FOR PERCOLATION TESTING AND SITE EVALUATION

PROPERTY LOCATION
SUBDIVISION/PROPERTY NAME Nursery View LOT NO. 4B

Re: Nursery View, Lots 4a & 4b
Percolation Test Results A521620
Tax Map: 2 Parcel: 144

PERCOLATION CERTIFICATION PLAN
REVISED WILDES
NURSERY VIEW
LIBER 649 FOLIO 451

PROPOSED LOT 4B

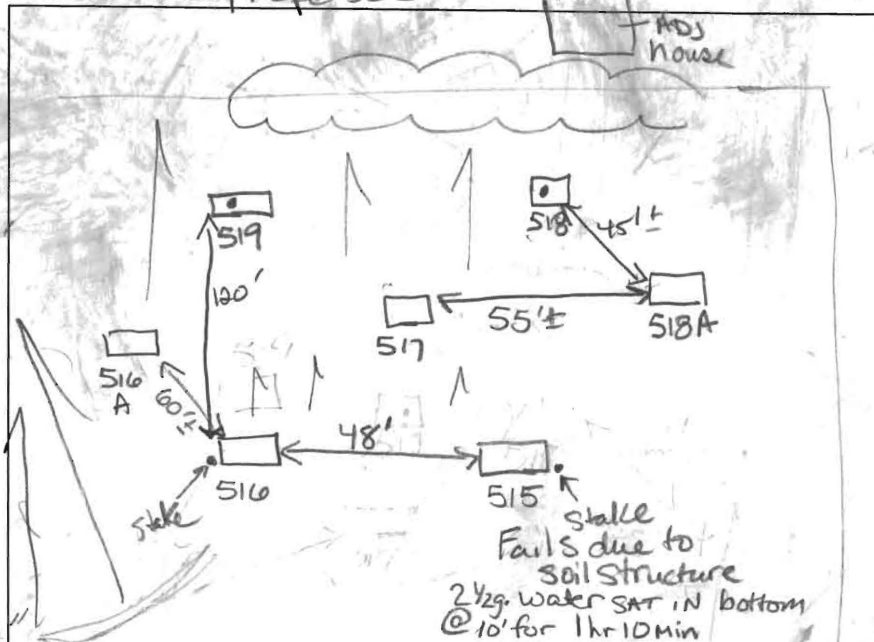
Holes lower than stake 517 best soils. Hole 517 is Marginal, hole 515 fails. Two non-planned holes dug to allow some flexibility w/ SDA design.

Proposed well loc. not acceptable

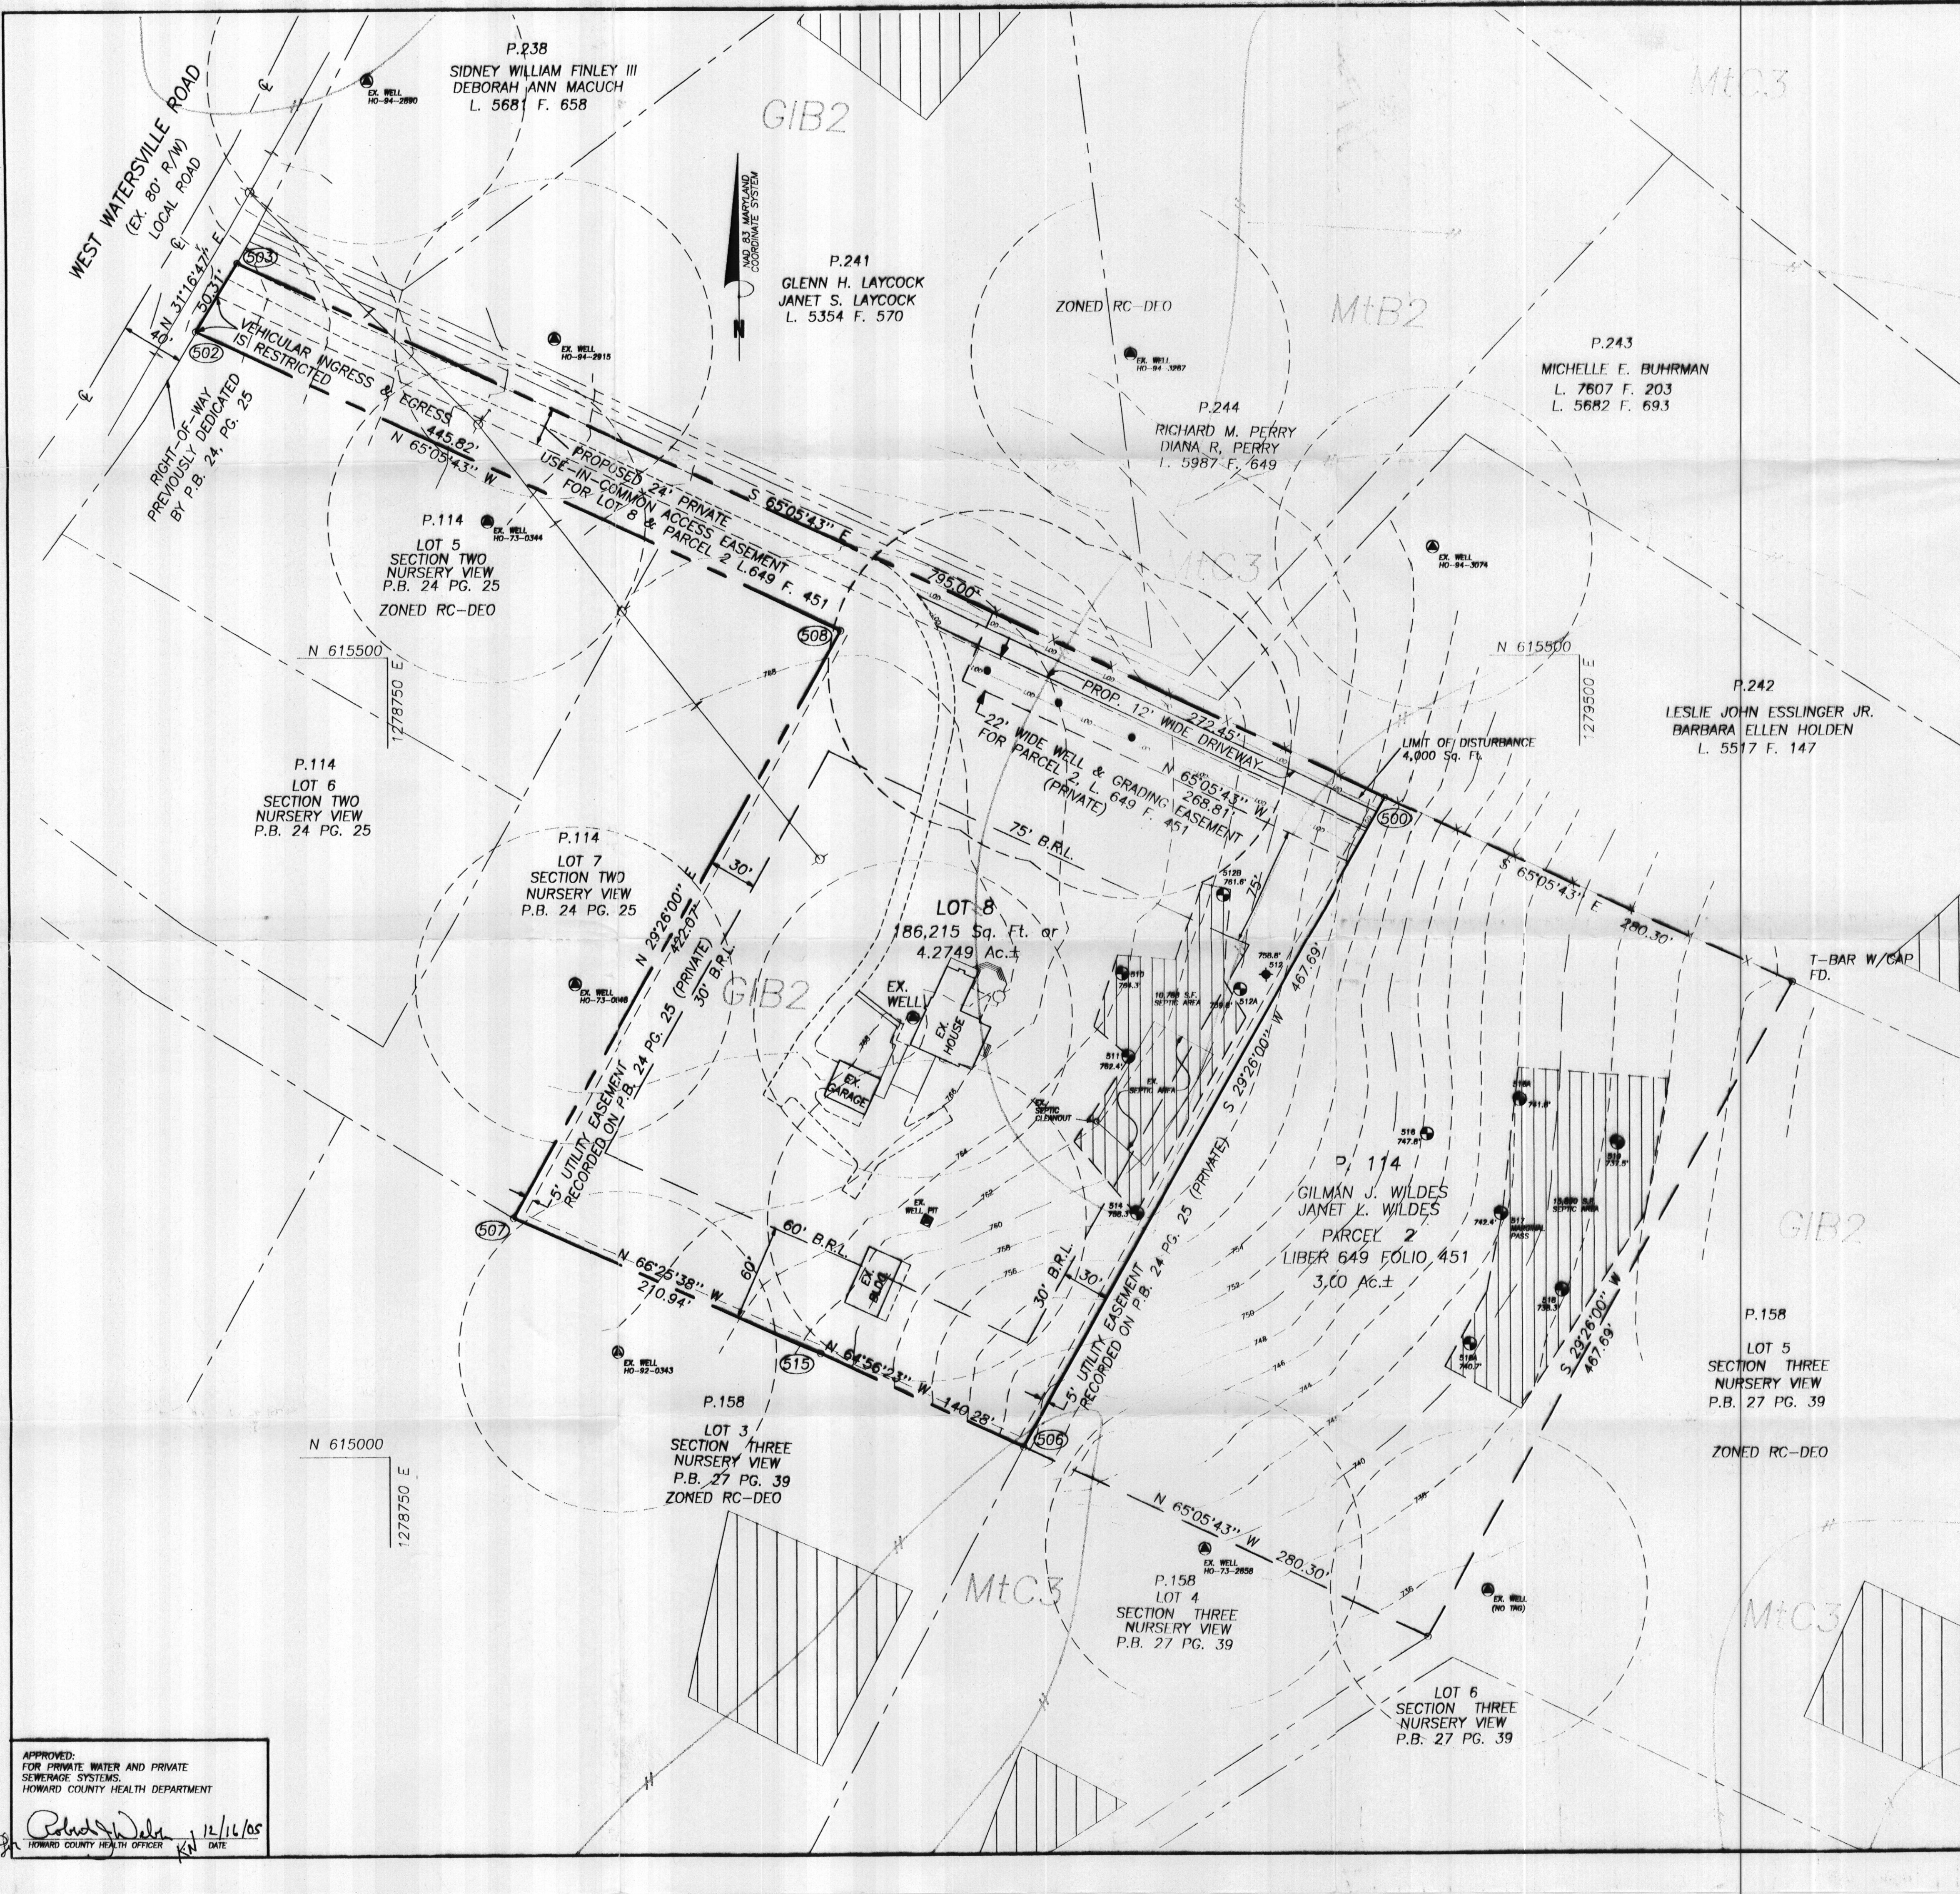
Percolation testing conducted on 1/20/05 yielded marginally acceptable test results in a few areas resulting in necessary septic area adjustments. Percolation test hole 512 yielded excessive rock and percolation test holes 517 & 518 contained tightly structured soils. Enclosed are a copy of the percolation test results and generalized areas of acceptable soils to configure your septic disposal areas.

- field locate all test holes and label with spot elevations for each test hole, and mark each hole as passed or failed, including the additional dug holes not on current plan
- Identify total SDA for each lot
- show a 1500 square-foot well box **in a different location** than shown for Lot 4b (attached is a possible solution of well sites along the right of way maintaining 100' from the septic disposal area of Lot 4a)
- show new location of proposed house site for Lot 4b maintaining at least 20' from the septic disposal area
- Add to the General Notes a statement for the existing well in well pit on Lot 4a to be abandoned and sealed prior to final plat recordation
- ensure all General Notes are included on plan, and also include the date the lot was established
